**TOWN OF NEWBURGH
PLANNING BOARD
TECHNICAL REVIEW COMMENTS**

PROJECT NAME: ADS PROPERTIES CAR WASH
PROJECT NO.: 2021-04
PROJECT LOCATION: SECTION 95, BLOCK 1, LOT 14.1
REVIEW DATE: 12 SEPTEMBER 2025
MEETING DATE: 18 SEPTEMBER 2025
PROJECT REPRESENTATIVE: GNS GROUP

W.1

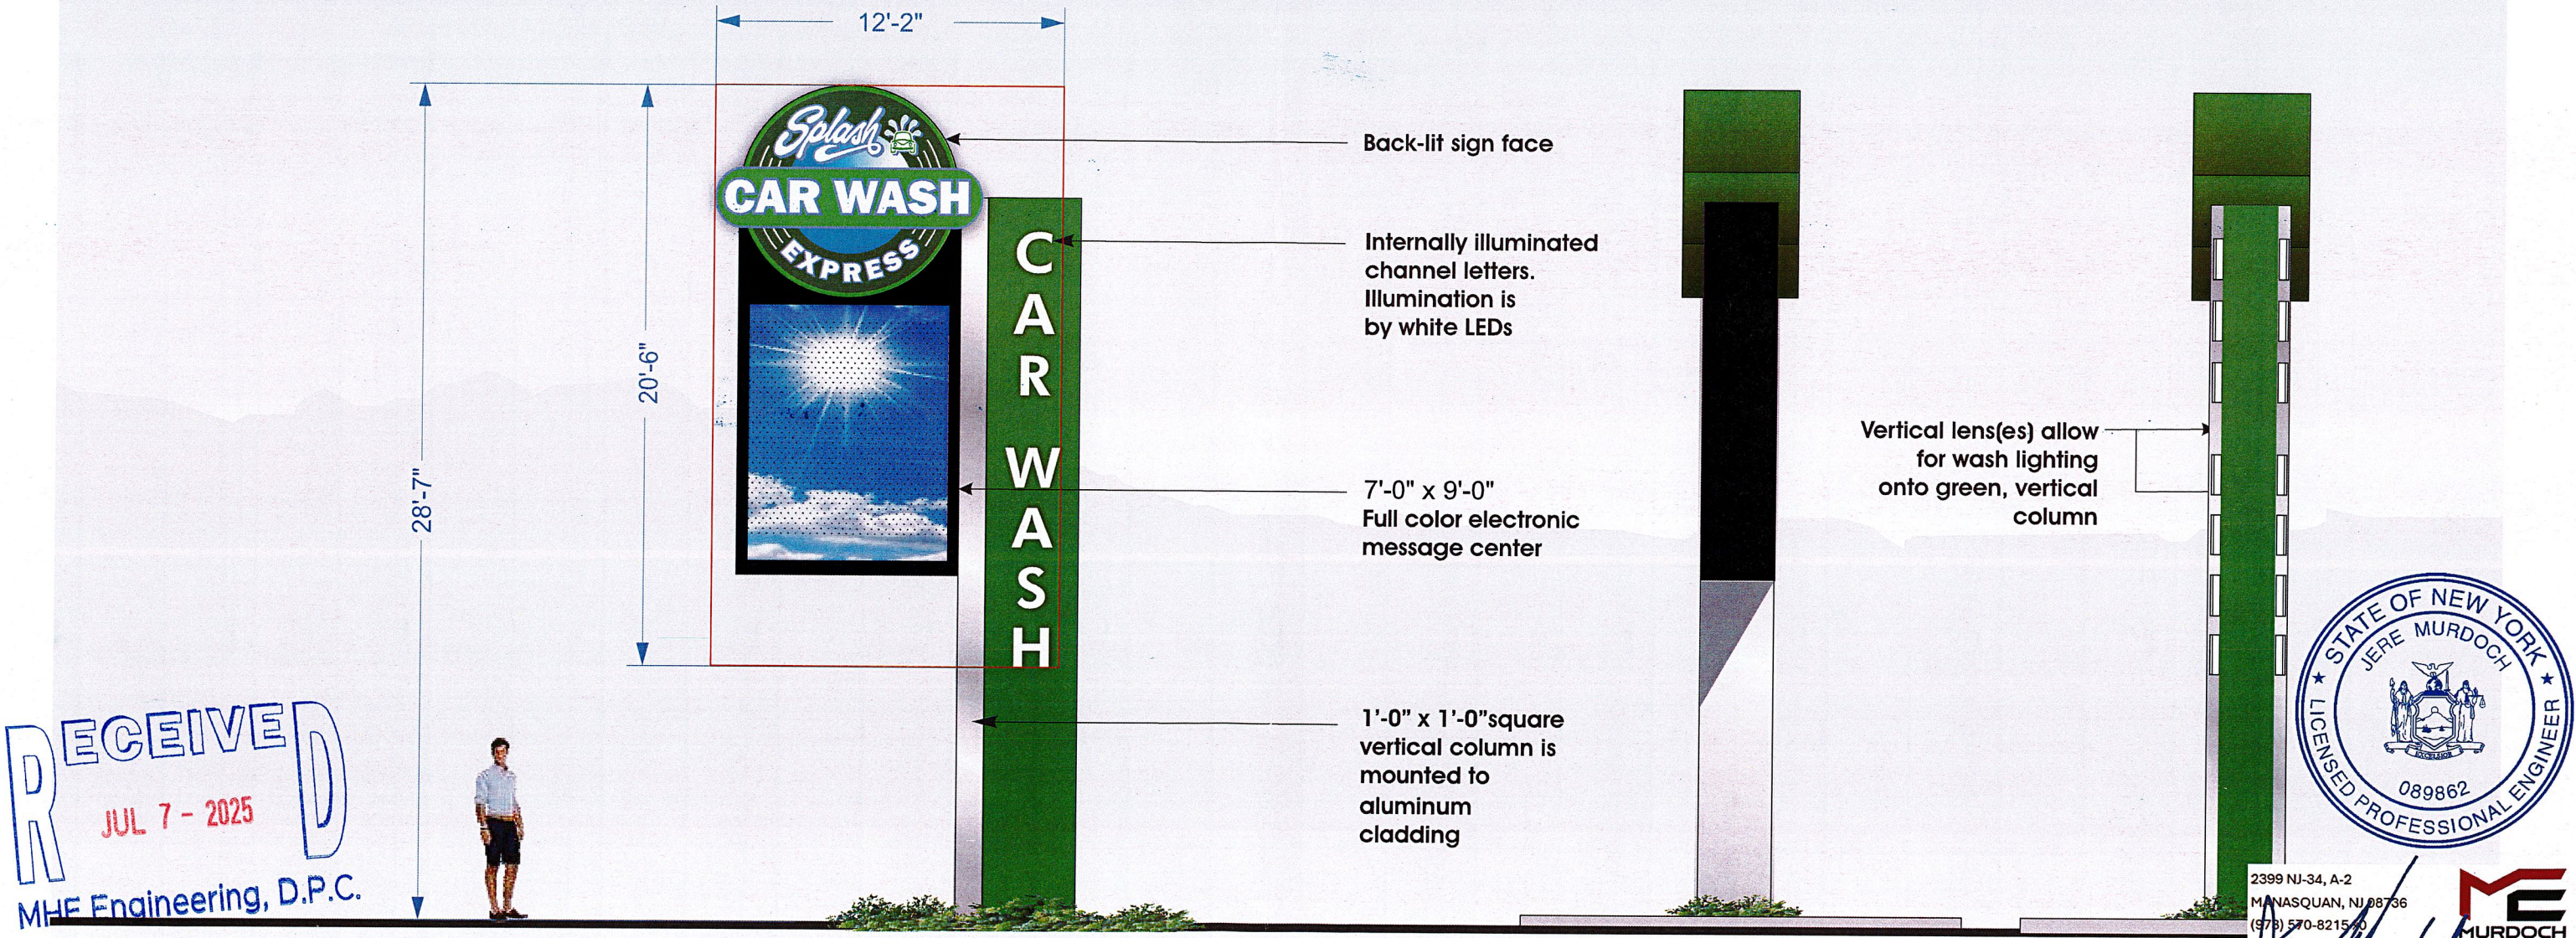
1. The project is before the Board for a Public Hearing on the proposed electronic sign. Electronic signs are special uses and require a special use permit by the Planning Board.
2. Orange County Planning has issued a local determination with no comments on the proposed electric sign.
3. Electronic signs must comply with Code Section 185-14P.
